## Floyd Hill Design Technical Team

### Meeting Summary

April 7, 2023, 9:00 AM to 12:00 PM

(Figure 1. Diagram and photo example of Type 9 Barrier with flat back)

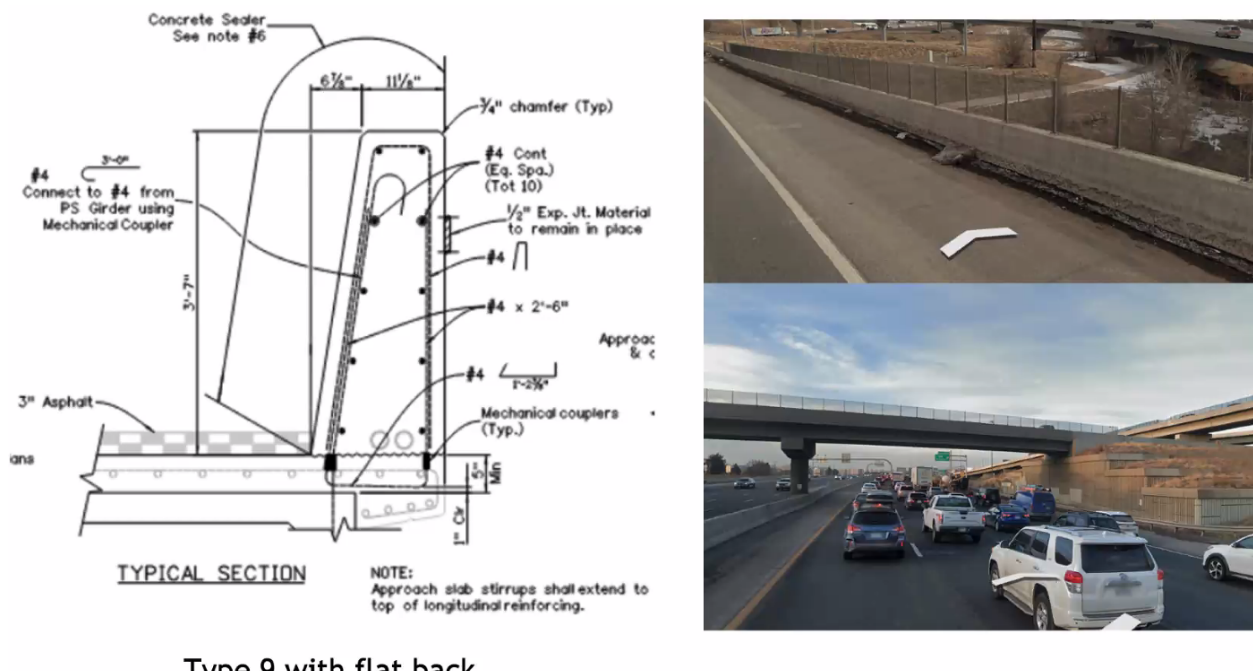
- **Q:** Are there any potential implications for weight differences between types?
  - **A:** The type 9, solid concrete weighs more, but it does not change the bridge structure type. The widths are the same for both types.

- **Q:** What is the height difference between barriers in Glenwood and these types? Does that difference provide extra safety in large truck accidents?

- **Q:** Is the cost comparable?
  - **A:** Fairly sure.
- **Q:** Wouldn't the solid concrete of type 9 keep a truck from going over better?
  - **A:** Both type 9 and 10 have been crash tested for the same safety loading

- **A:** Glenwood Springs are shorter under old requirements. The current MASH standard requires a height of 3' 7". The Glenwood plans show a height of 2' 10". A delta of 9" in height. Regarding prevention of trucks going over rails, the requirements are probability-based and FHWA and AASHTO have determined that the added height improves safety significantly.

(Figure 2. Diagram and photo example of Type 10 Barrier with flat back)

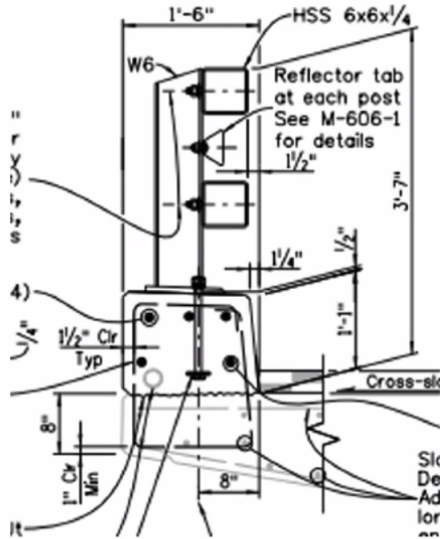
- **Q:** What difference does this make to snow removal?
  - **A:** No real impact between options; for either type a snow fence will be placed on the backside wherever there is trail, creek, a cliffside, or a roadway underneath

(Figure 4. Diagram of Greenway Trail Typical Section)

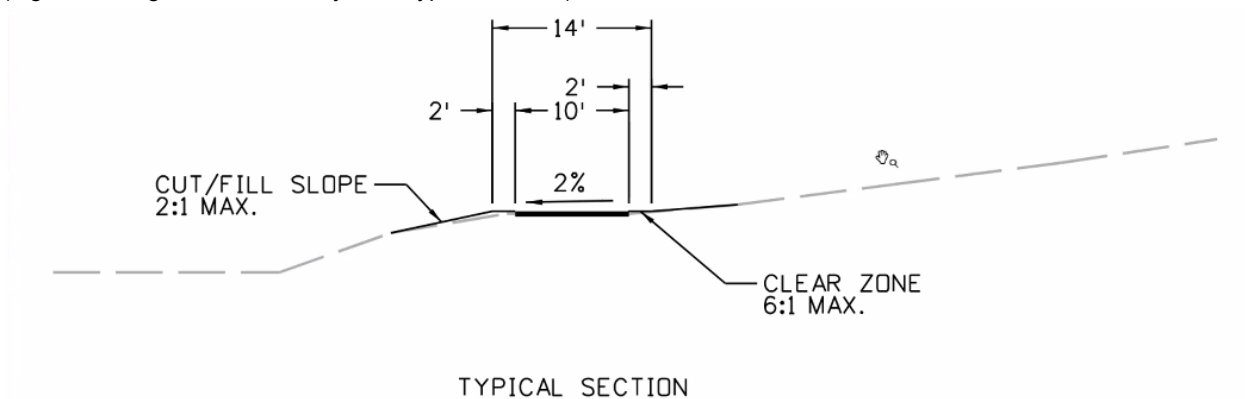
- **Q:** What width is required for ambulance access?
  - **A:** A width of 10 ft should accommodate an ambulance
- **Q:** Will there be snow removal impacts? Can plows fit?
  - **A:** There are no plans to begin plowing the greenway or change from the snow removal plans in place

(Figure 6. Diagram of Bridge P, Proposed Trail Typical Section)

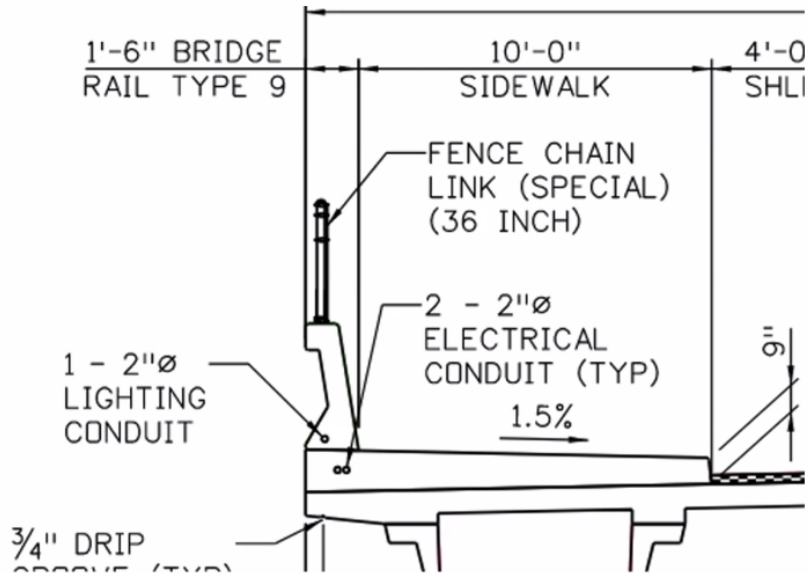
- **Q:** Will there be lighting on the bridge? Pedestrians might be fearful of higher speeds and visibility.
  - **A:** Drivers on bridge P will be coming to a stop so their speeds should be slow. We can consider lighting in future phases of design.
- Power and communications utilities that are along the greenway need to be relocated
  - Current design eliminates utility poles and buries utilities generally following the path of the Greenway.
  - Utility changes start at Hidden Valley Interchange and progress through the Saddle Cut to US-6 interchange. Then they will cross to the North side of US-6 and stay along US-6 from that point forward.

(Figure 7. Map of Utilities along Central Section of Project Area)

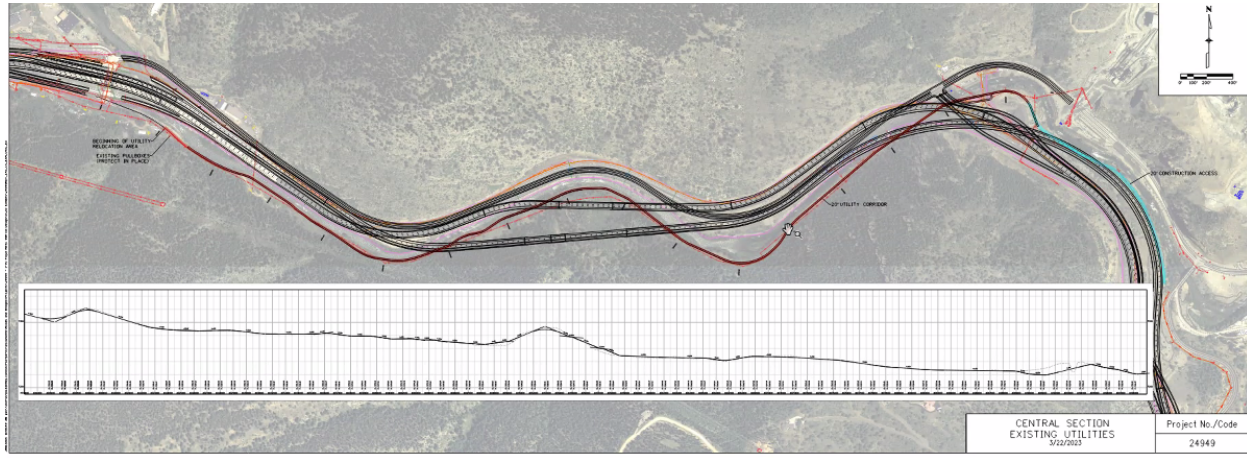
- **Q:** Will increased utility presence impede pedestrians and bike use?
  - **A:** Utility trucks use the greenway for access at present. The conditions of access for utility trucks is not expected to change.

- **Q:** What size of the equipment will be used? How much will you have to dig up?
  - **A:** Full-size excavators and support equipment will take up the current width of the path.

- **Q:** Will you re-pave the greenway to its current condition after utilities are buried?
  - **A:** Yes—the current asphalt condition will be restored before full resurfacing in later years.

- **Q:** Will the trail surface be cut up and re-paved repeatedly by the different utilities?
  - **A:** Haven't determined sequencing but the plan is to place all utilities in the same effort, but not necessarily side by side. However, the project team is unsure of their ability to direct the utilities on timeframe.

(Figure 8. Aerial Map of Saddle Cut area, Greenway trail to be redesigned vs. repaved)

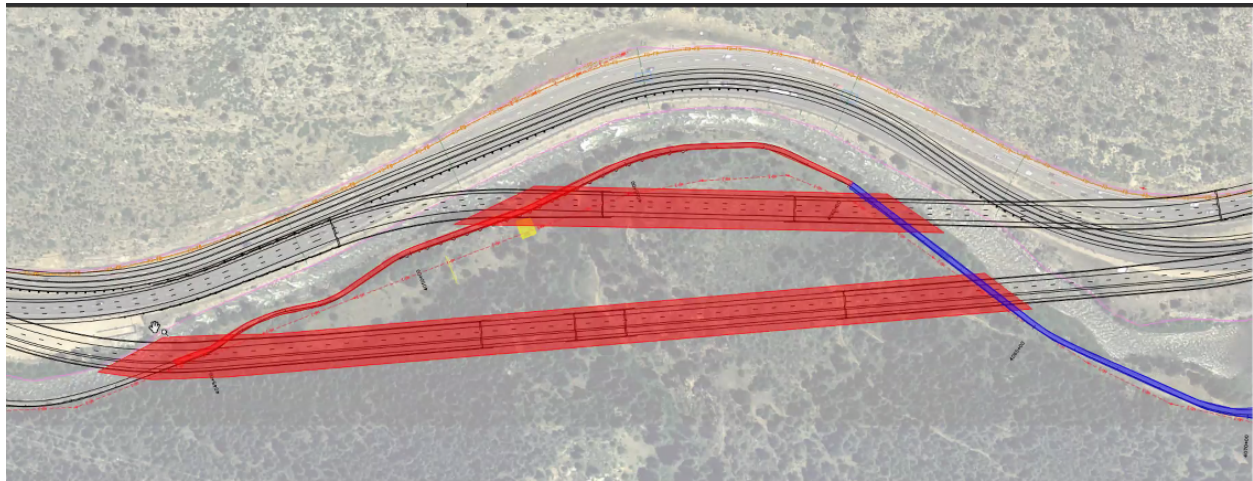
- **Q:** Do we need to consider emergency access for rafting?
  - **A:** Good point to bring up.
- Anything in red is a profile change for the greenway, and repaving where it is blue, yellow are historic areas for protection. The project team has more control over these areas.
